5.0 COMMENT SUMMARY AND RESPONSE TO THE DEIS

In this chapter, the Section of Environmental Analysis (SEA) responds to the comments on the Draft Environmental Impact Statement (DEIS).

Figure 5-1
Southwest Gulf Railroad
Potential Wetlands Crossed
by Eastern Alternatives

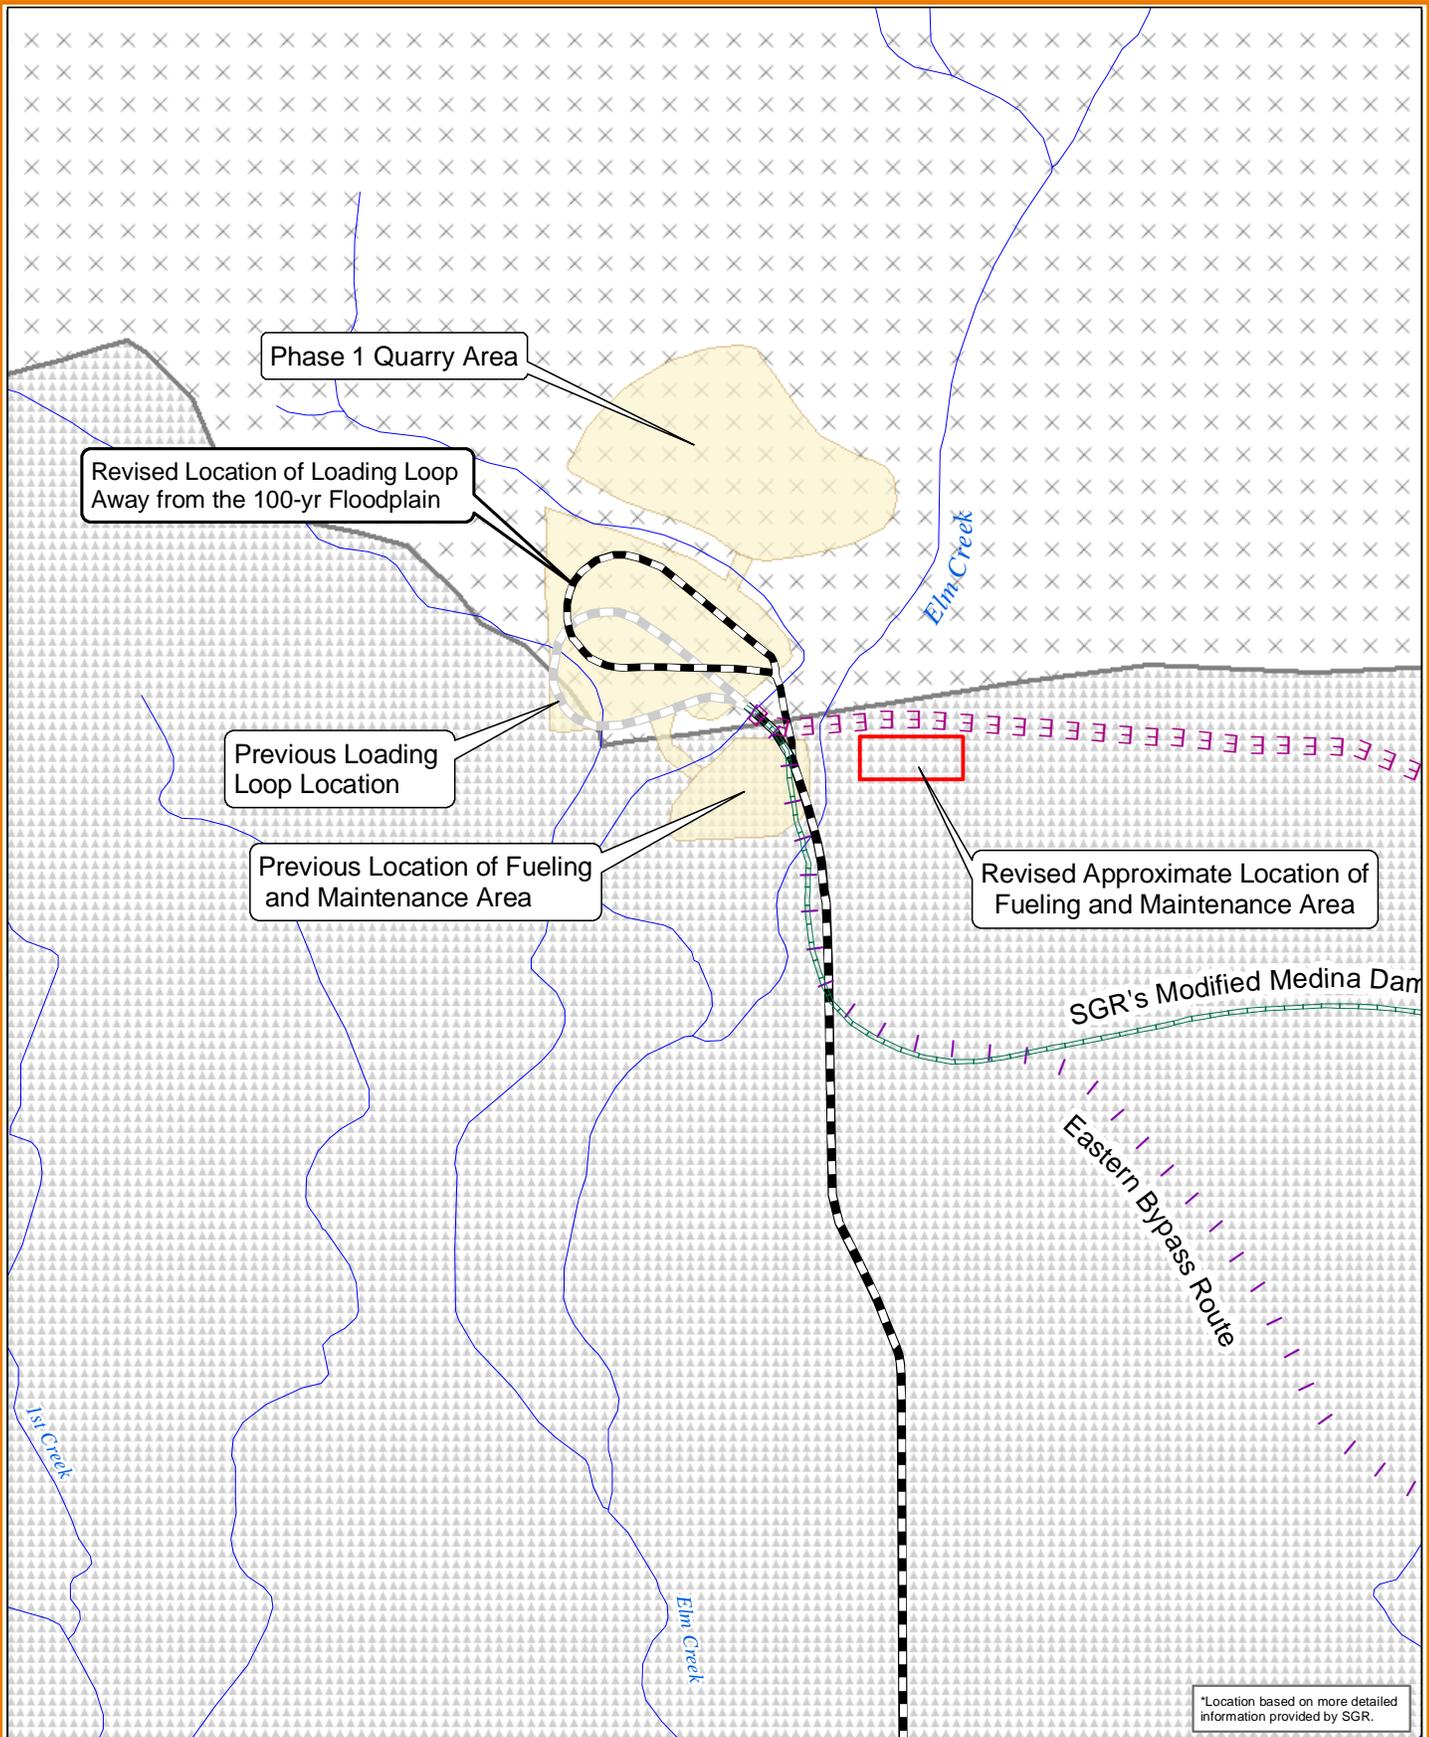
Comment GH-01, #EI-1287: A figure showing the location of landslide/mass movement hazards would be helpful to include in Section 3.6.2. Figure 3.6-1 is only a general atlas of the geologic outcrops in the area and does not really show site-specific information. In addition, the colors on this map make it very difficult to follow routes.

Response: Although the information requested is readily available from the USDA soil survey for Medina County, this FEIS includes a 1:24,000 scale map coverage of the alternative alignments for the SGR rail line showing the extent of hydric soils in the project area. See Figure 5-1 of this FEIS.
